**RESPONSE TO QUESTIONS 1, 2, 3, 4, 5, 7,
10, 11, 12, 13, 14, and 16**

August 1989

Pacific Gas and Electric Company

Diablo Canyon Power Plant
Long Term Seismic Program

Figure Q16-17

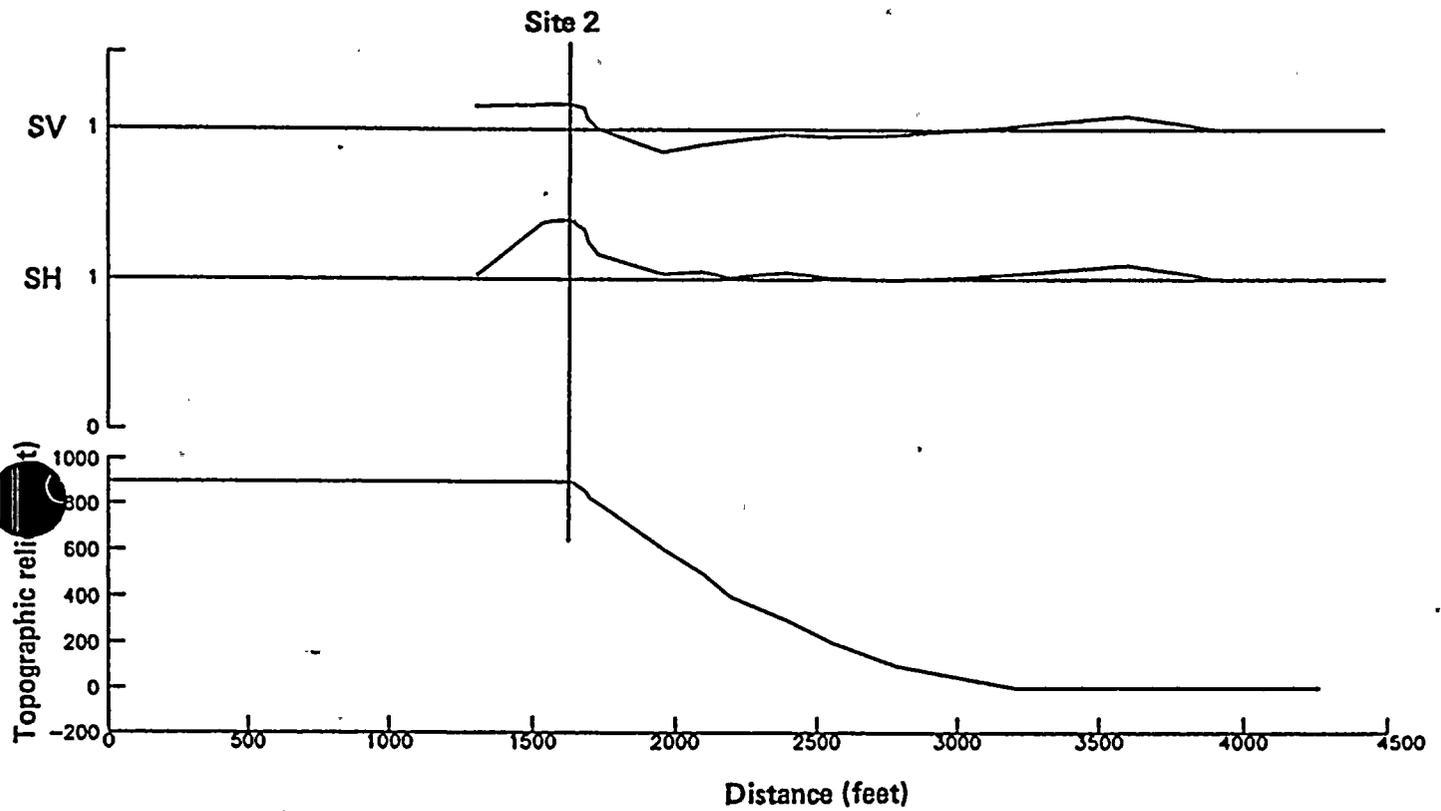
Recent work on the Nahanni earthquake Site 2 data (Weichert, 1989) and in the San Fernando earthquake Pacoima Dam recording (Anooshehpoor, 1988) indicate that the high ground motions recorded may not be due to site effects. In view of this, modification of these records to account for topographic amplification is questionable. What would the ground motion estimates be without these modifications?

To test this hypothesis, a numerical study of topographic effects at the two Nahanni sites was conducted using finite difference calculations; the results are shown in Figures Q16-16 and Q16-17. The procedure used is the same as that described in the response to Question 12 of this submittal. The topographic profiles were derived from the 1:50,000-scale elevation contour map shown in Figure Q16-15. The upper slopes of the two profiles are very similar, but Station 2 is at about 300 feet higher elevation. At each site, the accelerograph was located close to the edge of a steep slope. The ratio of peak acceleration on the ground surface to that for flat (free-field) conditions shows similar effects, with amplification of both SV and SH waves over the edges of the slopes, and some deamplification over the slopes. At the strong motion sites, there is amplification of SH by 35 and 45 percent for Stations 1 and 2 respectively, and amplification of SV by 10 and 15 percent respectively. For both SH and SV, the amplification at Station 2 is slightly larger than at Station 1. This is consistent with the observation by Weichert and Horner (1987) that the peak accelerations of the aftershocks at Station 2 are larger on the average than at Station 1. We conclude that the strong motion recordings of the Nahanni earthquake at Stations 1 and 2 were both amplified by topographic effects.
